Watermaster Review Form: Water Right Transfer

T-14142 Map

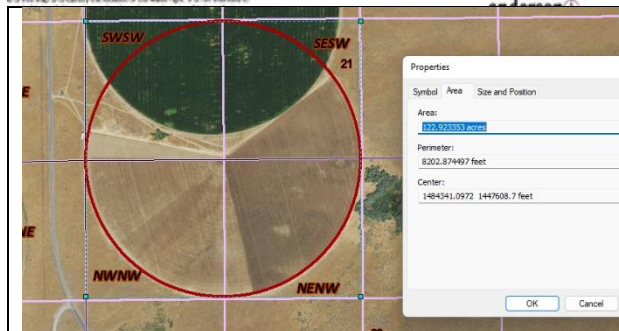
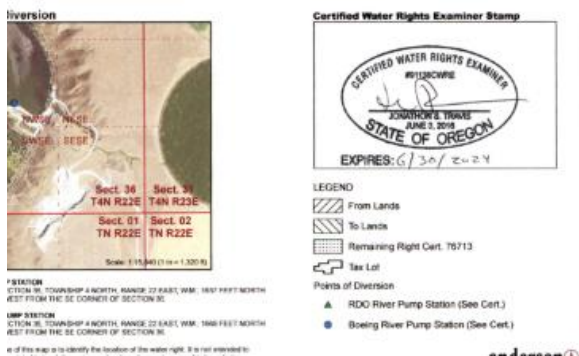
showing $35.8+2.4 = 38.2$ Ac. in NW NW of Sec. 28

showing $35.2+2.1 = 37.3$ Ac. in NW NW of Sec. 28

for a total of 75.5 Ac. out of 8 Ac.

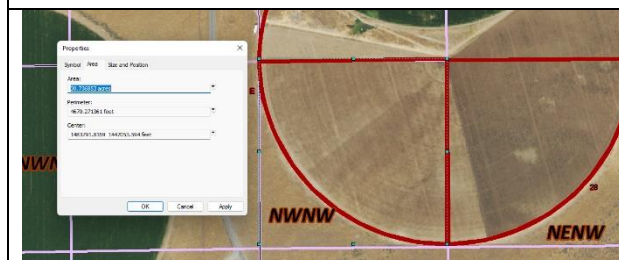
This is an enlargement of ~ 14.5 Ac. as shown in the following

Full quarter circle ~122 Ac.

Sec. 28 NE NW ~ 30.3 Ac. in production

Sec. 28 NW NW ~ 30.7 Ac. in production
